## 2023 ENVIRONMENTAL STATEMENT ADDENDUM CHANGE REQUEST 2

HyNet Carbon Dioxide Pipeline DCO

**Document Reference Number D.7.22**

**Applicant: Liverpool Bay CCS Limited**

### Embedded Pipe Bridge

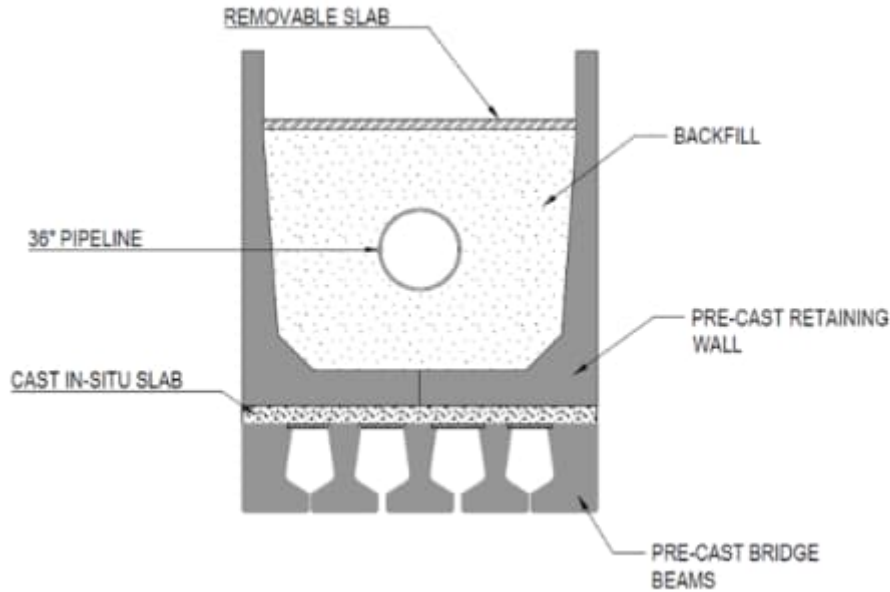
- 2.1.9. The following section of text to explain the characteristics of the embedded pipe bridge should be inserted after **paragraph 3.5.5** of the 2022 ES [APP-055]:

*The DCO Proposed Development includes an option to install an embedded pipe bridge across the Alltami Brook in case the preferred option of installing the pipeline beneath the watercourse via open-cut trench methodology is not authorised.*
